February 8, 2018

Re: Water Quality Management Letter for Sewer Service Area Amendment Request #1707 –
CUSA - Madison

Map 1 Amendment Area

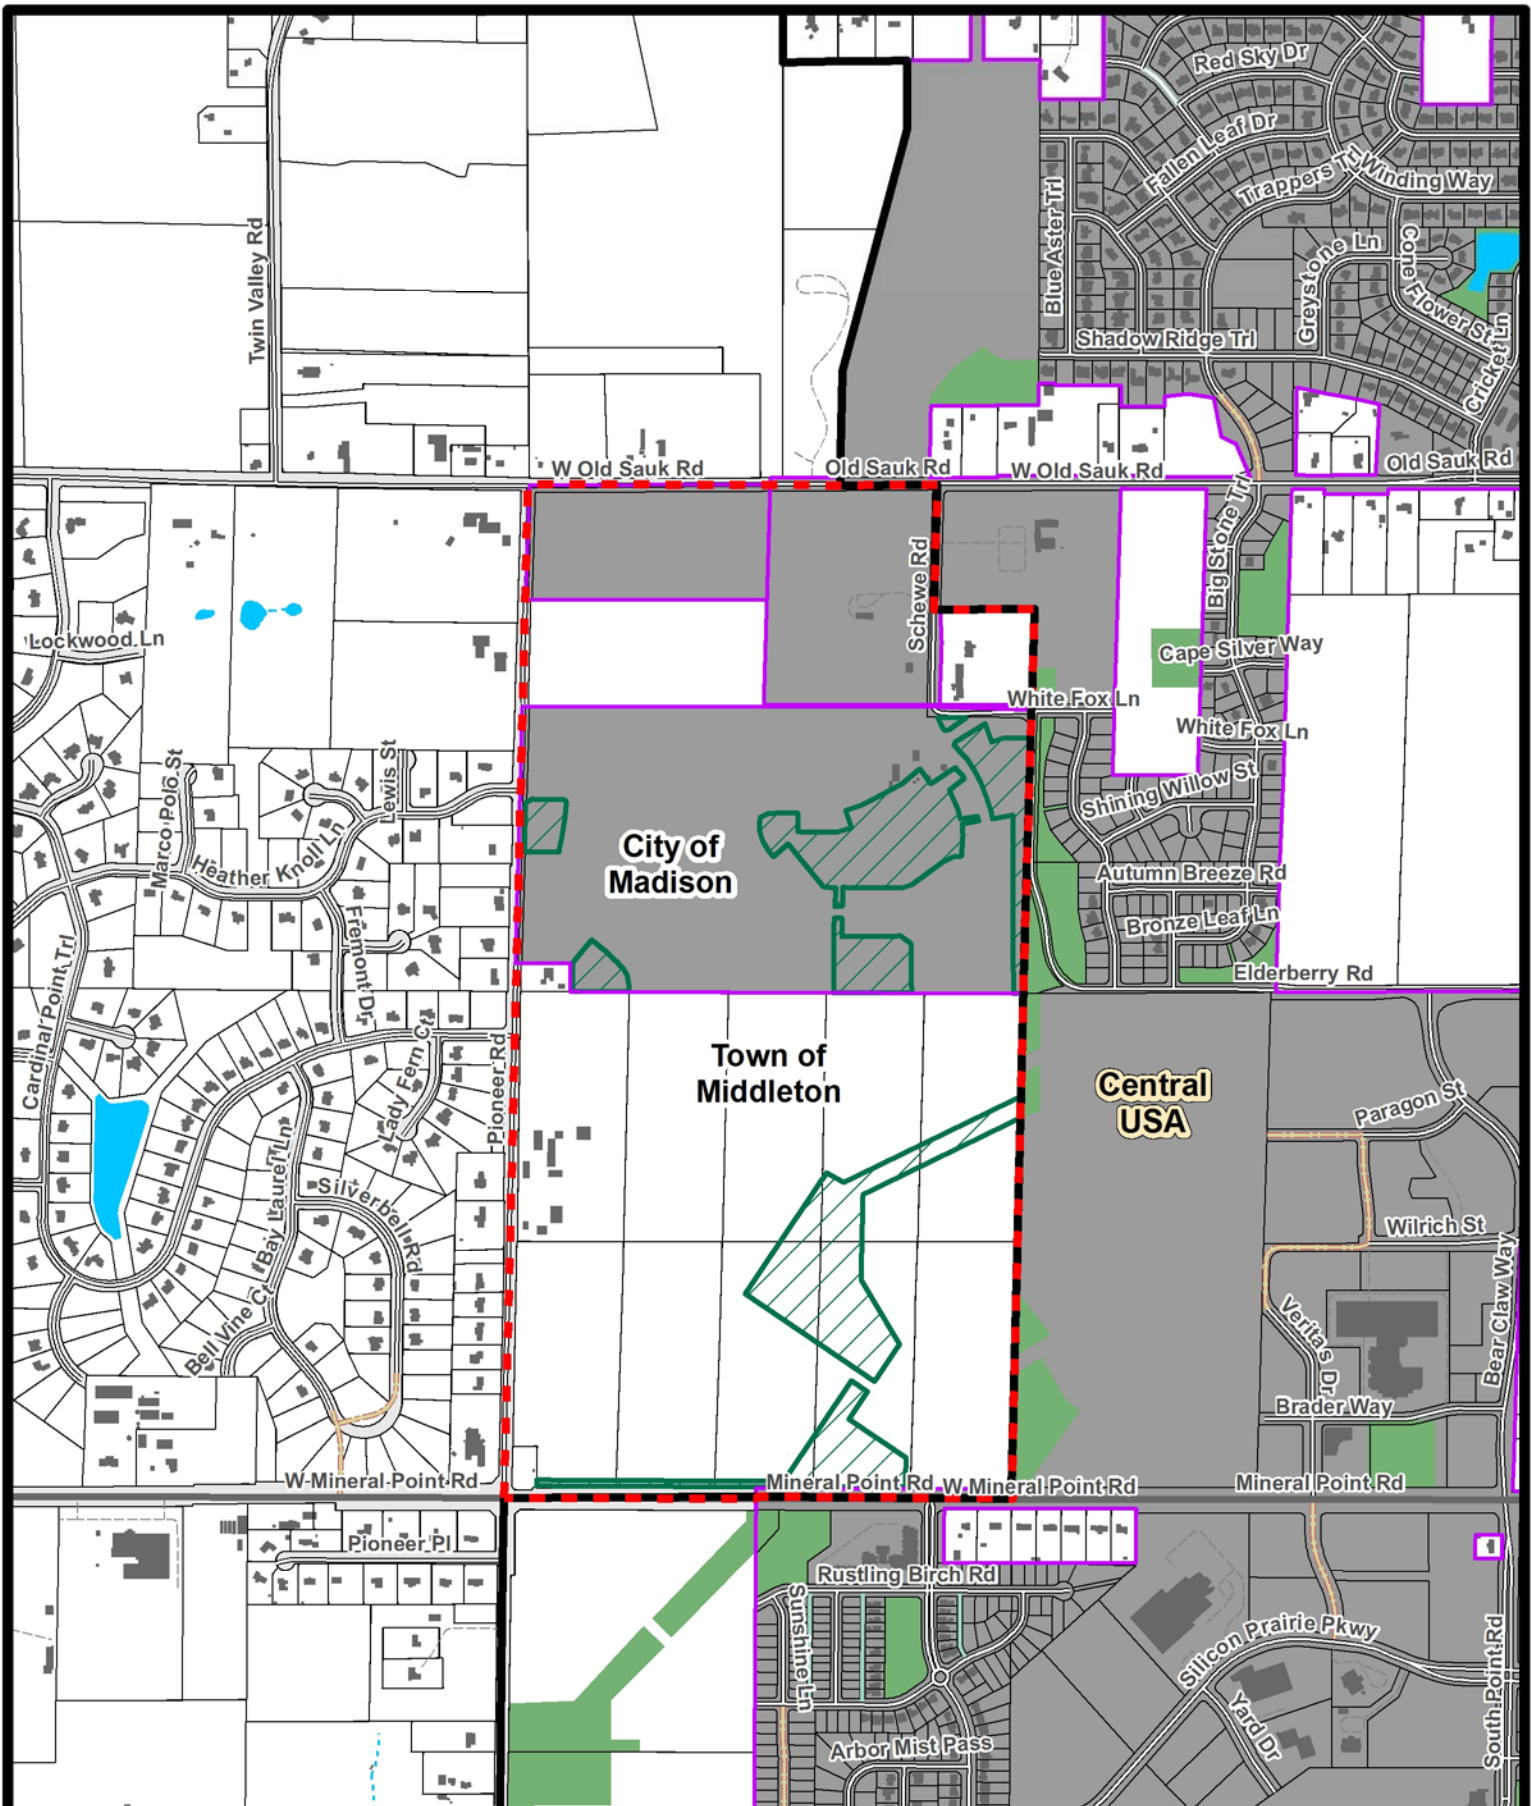
On December 6, 2017, the City of Madison submitted a sewer service area amendment application to the Capital Area Regional Planning Commission requesting an expansion of the Central Urban Service Area. The proposed amendment includes the addition of approximately 312.8 acres of land. The proposed amendment area does not include any environmentally sensitive areas that would require inclusion in environmental corridors in accordance with the adopted environmental corridor policies and criteria of the *Dane County Water Quality Management Plan*. Non-riparian, steep, wooded slopes; the proposed stormwater management facilities; and planned park and open space have been included in environmental corridors. The environmental corridors total approximately 35.4 acres, for a net developable area of about 277.4 acres. A public hearing was held on the proposed amendment at the January 11, 2018 meeting of the Capital Area Regional Planning Commission. The City's application and the Commission staff's analysis report of the proposed amendment have been submitted to the Department's Surface Water Integrated Monitoring System.

At our February 8, 2018 meeting, the Capital Area Regional Planning Commission voted to recommend approval of this amendment to the Wisconsin Department of Natural Resources, based on the land uses and services proposed, and conditioned on the continued commitment of the City of Madison to pursue the following:

1. Submit a detailed stormwater management plan for Regional Planning Commission staff review and approval (in conjunction with DCL&WCD staff) prior to any land disturbing activities in the amendment area. The stormwater management plan shall include the following:

- a. Install stormwater and erosion control practices prior to other land disturbing activities. Protect infiltration practices from compaction and sedimentation during land disturbing activities.

- b. Control peak rates of runoff for the 1-, 2-, 10-, and 100-year 24-hour design storms to pre-development levels, in accordance with the City of Madison Stormwater Ordinance.

- c. Provide at least 80% sediment control for the amendment area based on the average annual rainfall, with a minimum of 60% of that control occurring prior to infiltration, in accordance with the City of Madison Stormwater Ordinance.

- d. Maintain the post development stay-on volume to at least 90% of the pre-development stay-on volume for the average annual rainfall period, in accordance with the City of Madison Stormwater Ordinance.

- e. Maintain pre-development groundwater recharge rates from the Wisconsin Geological and Natural History Survey's 2012 report, *Groundwater Recharge in Dane County, Wisconsin, Estimated by a GIS-Based Water-Balance Model* (a range of 9 to 10 inches/year for the amendment area) or by a site specific analysis, in accordance with the Dane County Stormwater Ordinance.

- f. Include provisions and practices to reduce the temperature of runoff, in accordance with the City of Madison Stormwater Ordinance.
 - g. When development proceeds in an order such that the City does not have the right, such as an easement or ownership, to increase flows to a downstream channel, infiltration shall be required such that the runoff-volume pre-development to post-development is matched during a 10-year design event, to the extent allowed by state statutes.

2. Conduct a field verification for areas of the development site considered suitable for infiltration including a site assessment for karst features as required by the Wisconsin Department of Natural Resources Conservation Practice Standard 1002 - Site Evaluation for Stormwater Infiltration.

3. Stormwater management facilities shall be placed in public outlots whenever feasible and designated as environmental corridor. Easements and perpetual legal maintenance agreements with the City, to allow the City to maintain stormwater management facilities if owners fail to do so, shall be provided for any facilities located on private property.

4. Delineate environmental corridors to include parks and stormwater management areas to meet the Environmental Corridor Policies and Criteria adopted in the *Dane County Water Quality Plan*. Submit plats showing environmental corridors for Regional Planning Commission staff review and approval prior to recording.
